California High-Speed Train Project

**RFP No.: HSR 11-16
Design Variance Report**

FRESNO STATION CROSSOVER DISTANCE FROM STATION
HST TRACK ALIGNMENT SPIRAL/VERTICAL CURVE OVERLAP
OCS CLEARANCE ASHLAN AVE
OCS CLEARANCE UNDER FUTURE RECONSTRUCTED FRESNO YARD OVERHEAD

DESIGN VARIANCE COVER SHEET

Regional Consultant's / Third Party Design Drawing Reference: TT-D1011 to TT-D1016

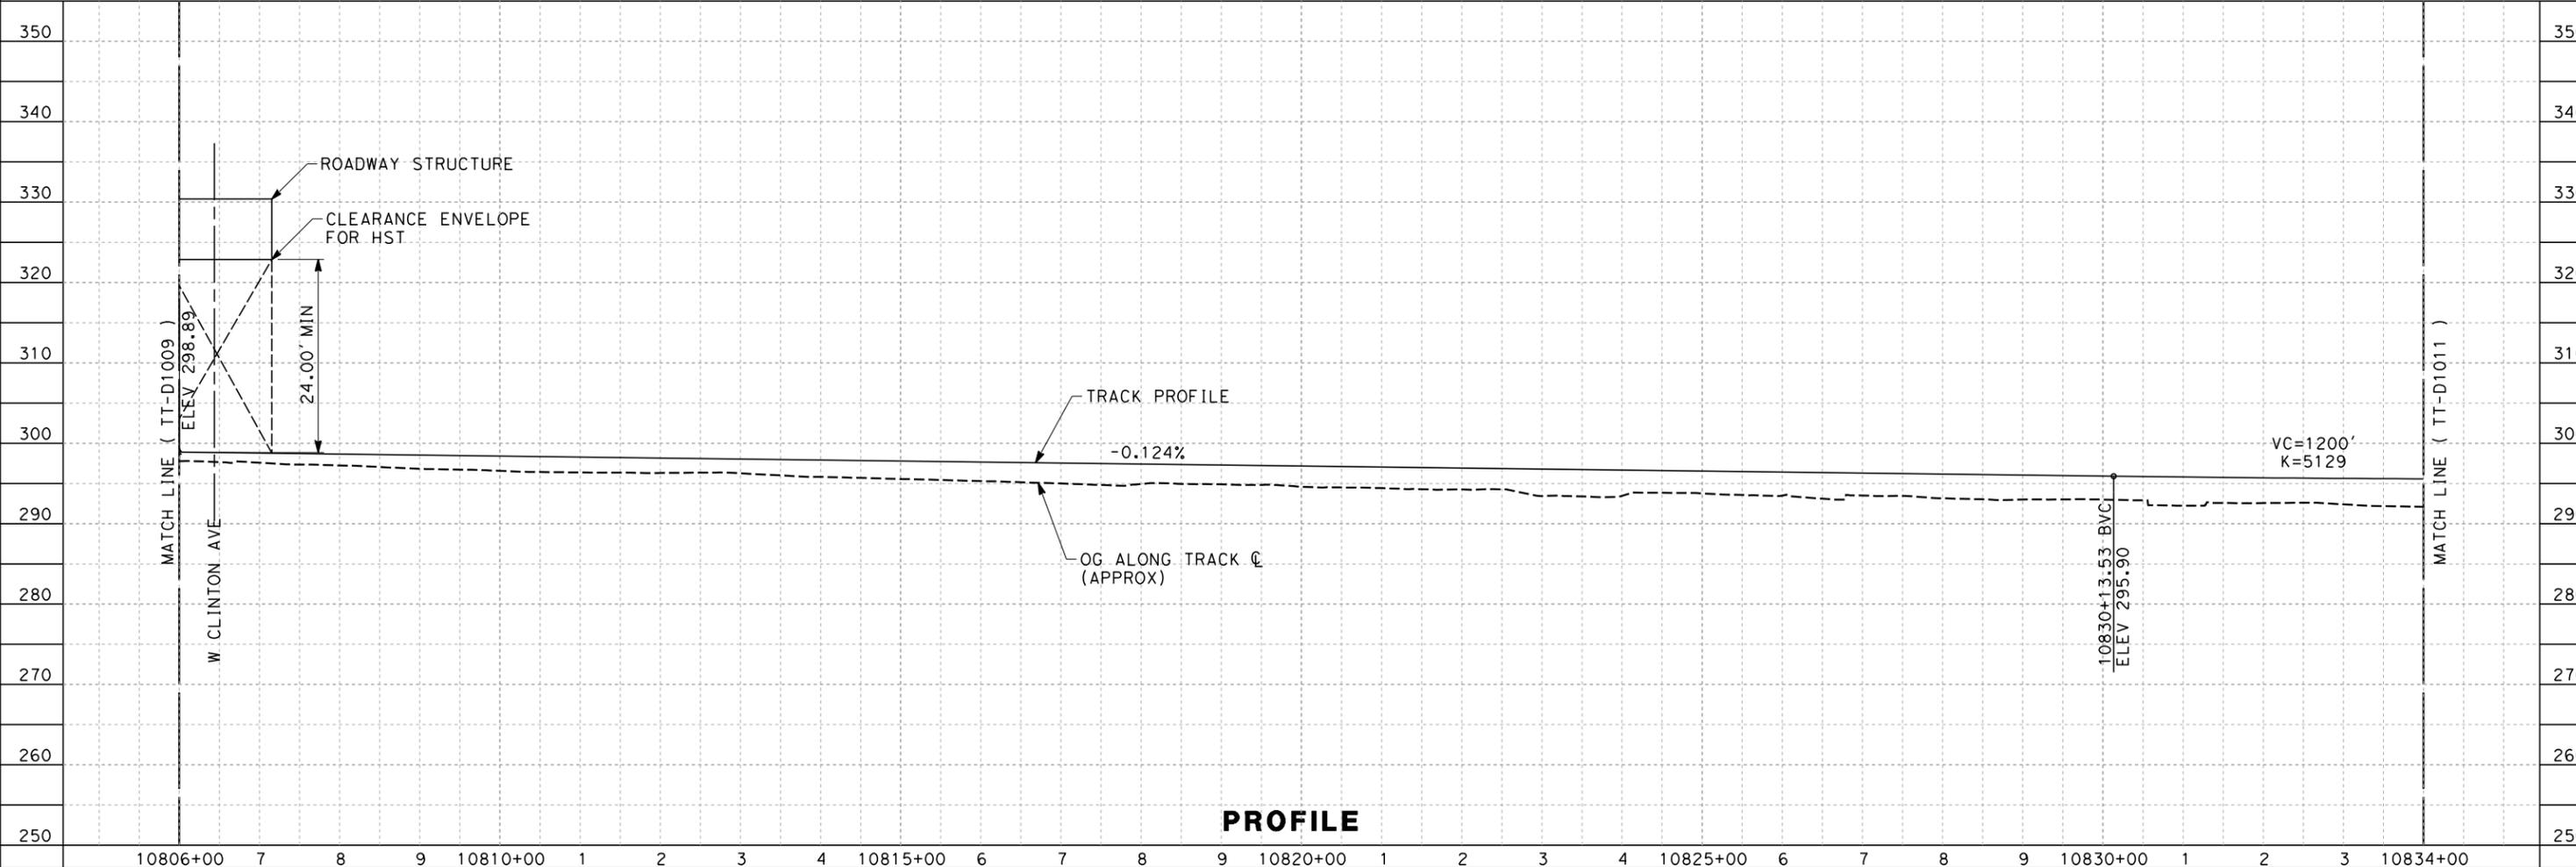
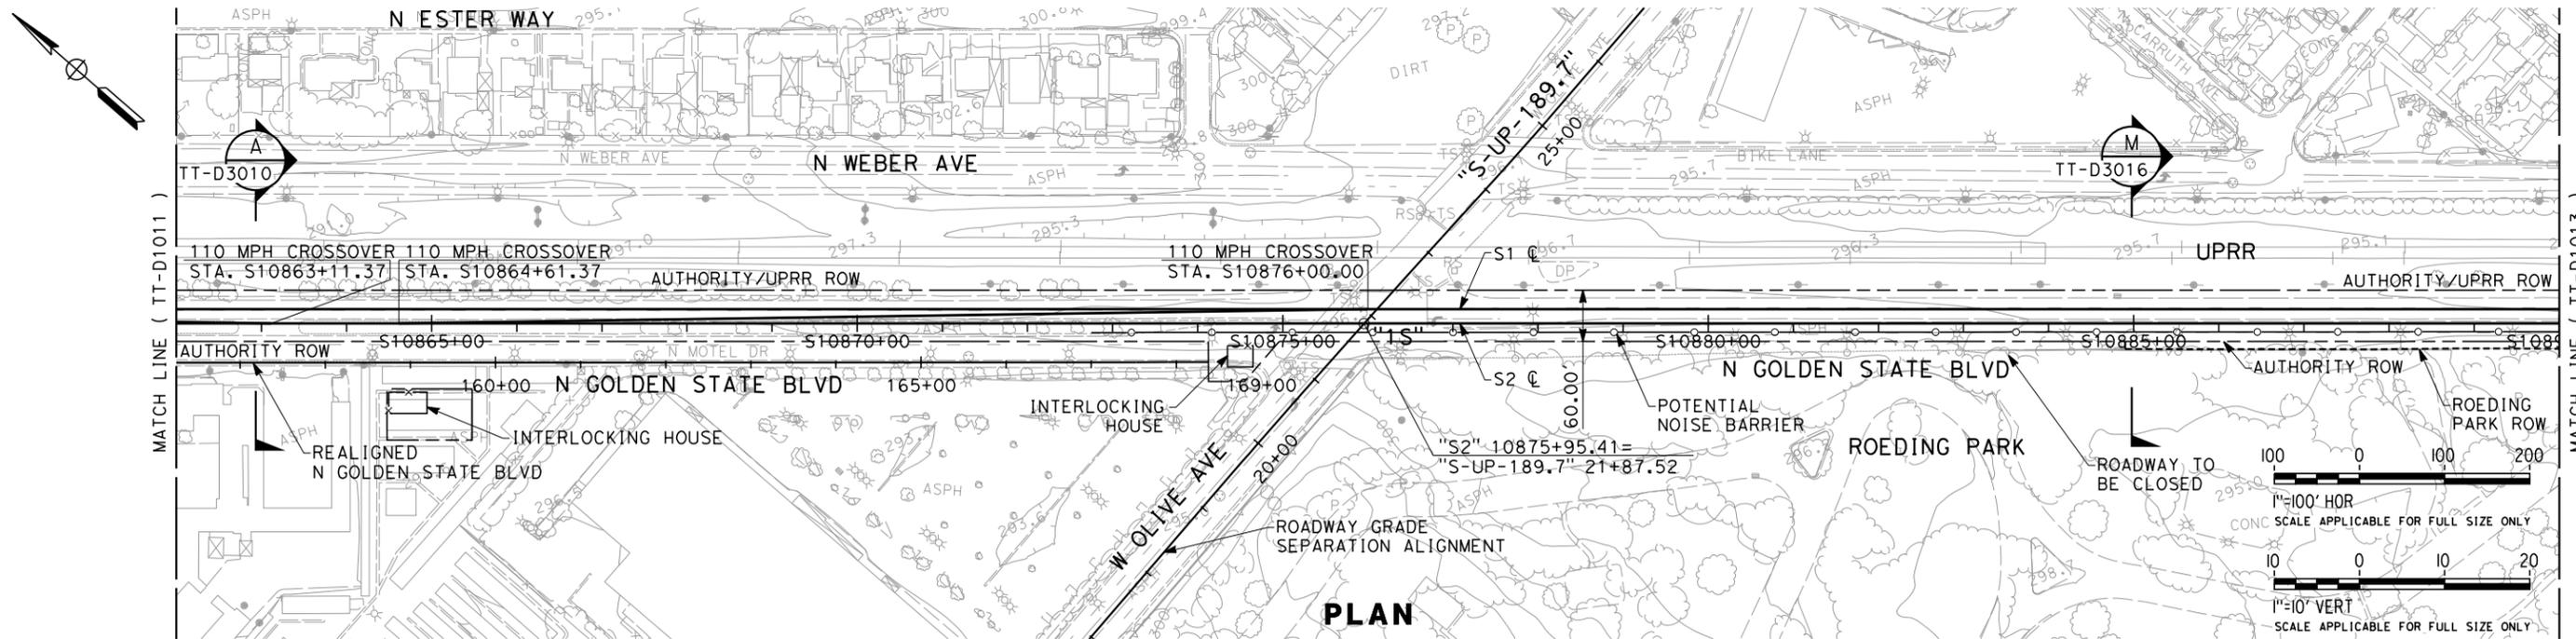
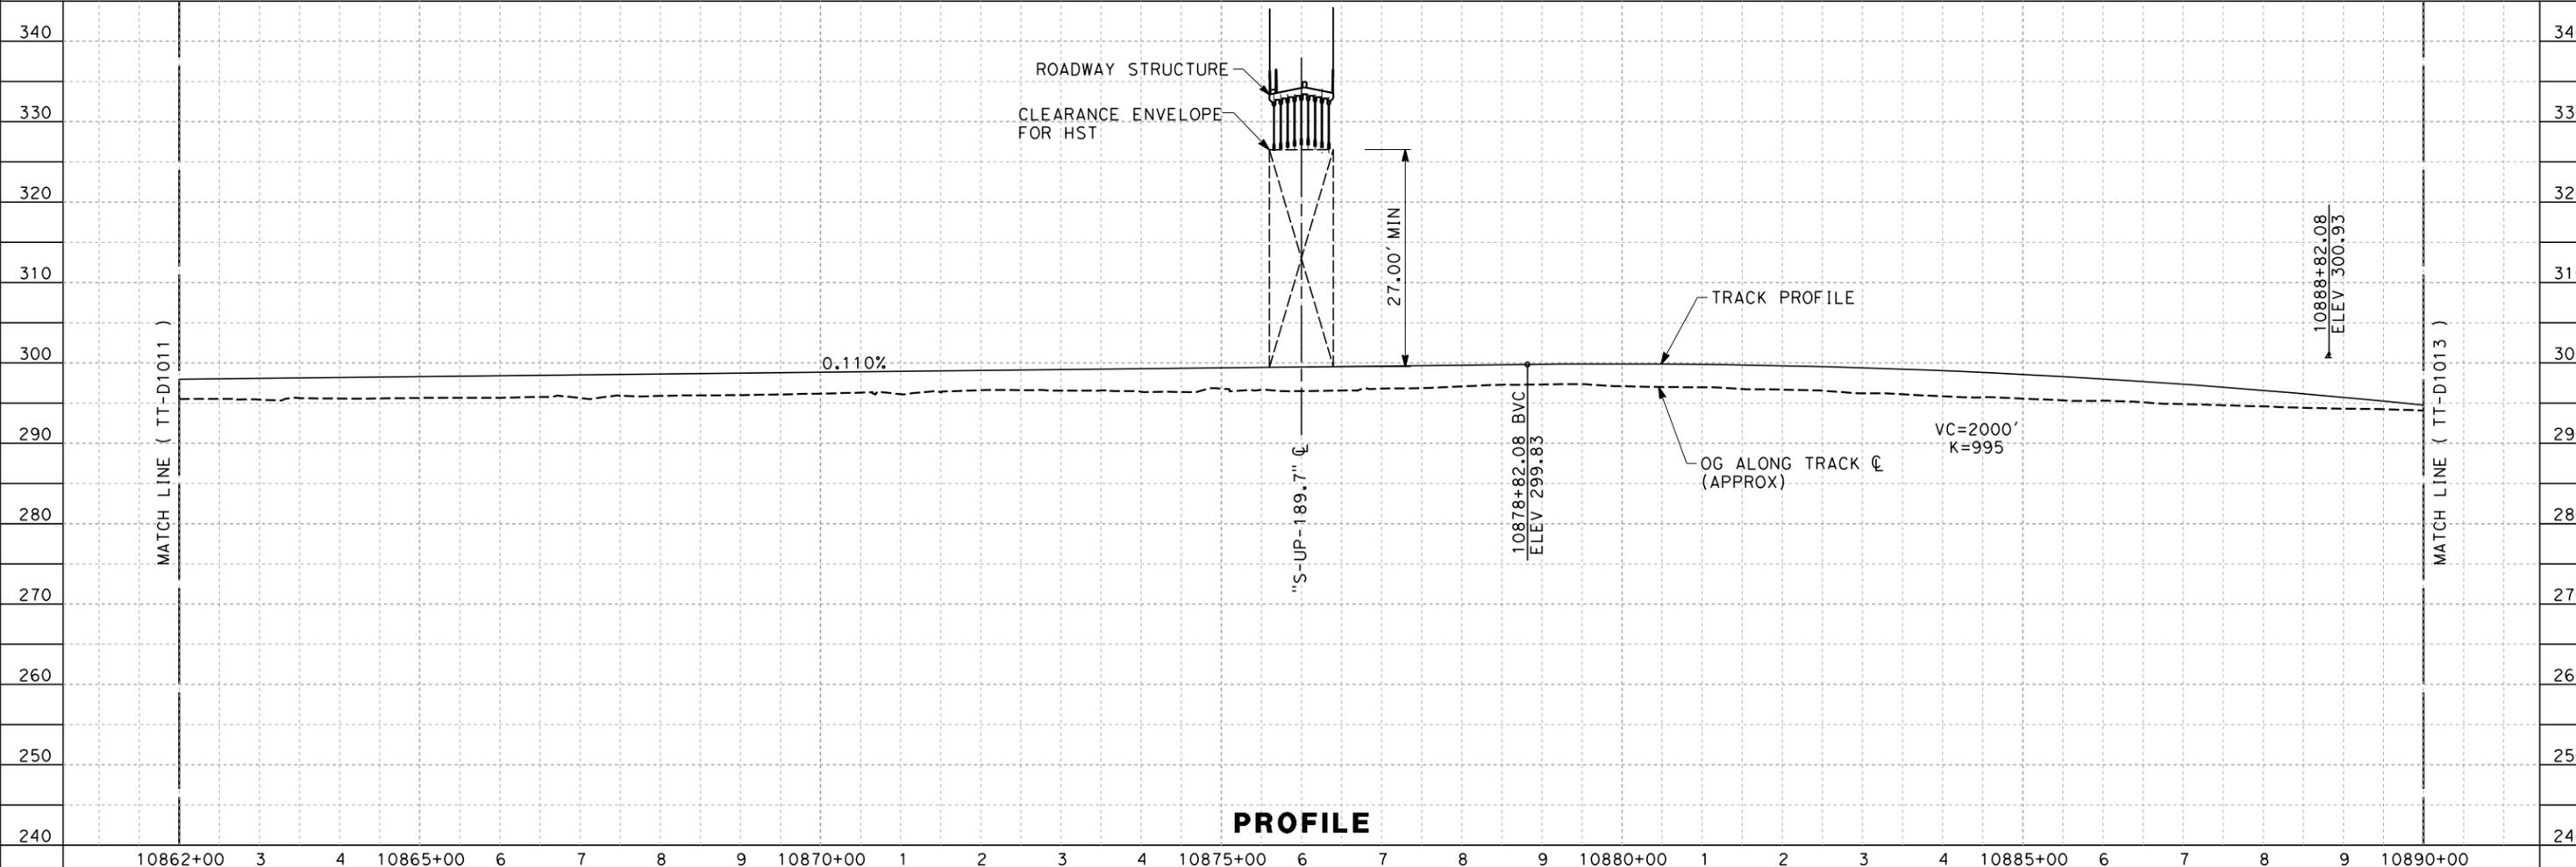
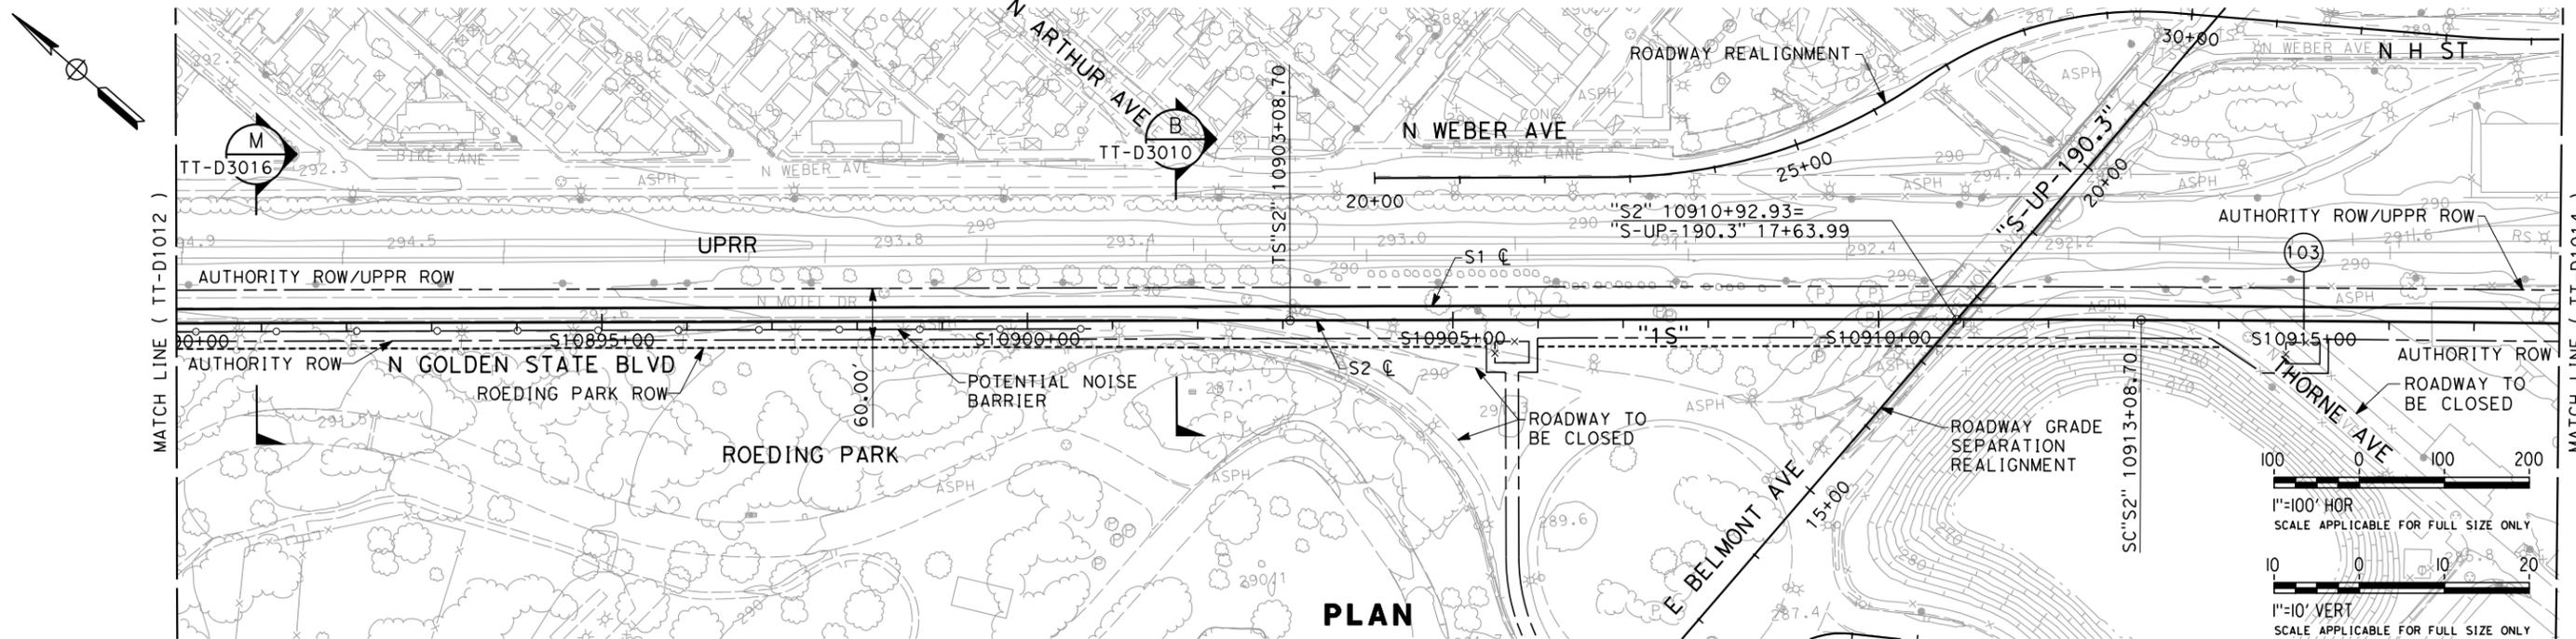
<p>CHSTP DESIGN REQUIREMENT Include reference to drawings, design criteria, technical memos, specifications</p>	<p>TM2.1.3 – Turnouts and Station Tracks Rev 0, 06/29/09 Figure 6.1.4 stipulates the desirable run time to determine the “minimum distance between the end of station turnout and crossover turnout, where they are on the same track,” should be 1.5 seconds, or a minimum of 1 second.</p> <p>Verbal advice from EMT stated that station crossovers should not be more than a mile from the station.</p>
<p>DESIGN CRITERIA REQUIRING A VARIANCE</p>	<p>Desirable run time to determine the “minimum distance between the end of station turnout and crossover turnout, where they are on the same track,” should be 1.5 seconds, or a minimum of 1 second.</p>
<p>REASON FOR REQUESTING A VARIANCE</p>	<p>Crossovers for Fresno stations at STA 10851+72.74 to 10863+11.37 and 108664+61.37 to 10876+00.00. Station platform ends are at 10970+00. This is a maximum separation of 14,127ft.</p>

<p>JUSTIFICATION FOR VARIANCE</p>	<p>Fresno Station is centered on Mariposa St and the station platform track approaches extend from Stanislaus St to the north and Santa Clara St to the south. The high-speed rail (HSR) descends into trench immediately after Stanislaus St in order to cross under abutments supporting the SR180 overcrossing of the Union Pacific Railroad (UPRR) tracks, spur tracks belonging to the San Joaquin Valley Railroad (SJVR) Company, and a canal that crosses under both the UPRR and the SJVR.</p> <p>The HSR is on a vertical curve as the tracks descend into the trench followed by a constant gradient of only 800ft at a gradient of 1.550%, followed by another vertical curve and then another section of 1,000ft at a constant gradient of -1.900%. The HSR emerges from the trench and is back at-grade on a constant gradient of 0.110% around 9,000ft (1.7 miles) to the north of the station platform turnouts. There are no sufficiently long sections at a constant gradient within the trench to accommodate a crossover with a design speed of 110mph (i.e., 1,139ft).</p>

<p>PROPOSED ALTERNATIVE DESIGN</p>	<p>Continue an at-grade alignment between W</p>

REQUIREMENT	<p>Olive and the station. This would require grade separation junction to carry the SJVR spurs (if feasible) and closure of Dry Creek. SR180 would require major works to the embankments and probable reconstruction of the abutments of the bridge crossing UPRR.</p> <p>It may be feasible to provide a crossover on the 1,000-foot section of constant gradient within the trench, but this would require the imposition of an 80mph speed restriction due the short crossover. This option was not recommended.</p>
--------------------	--
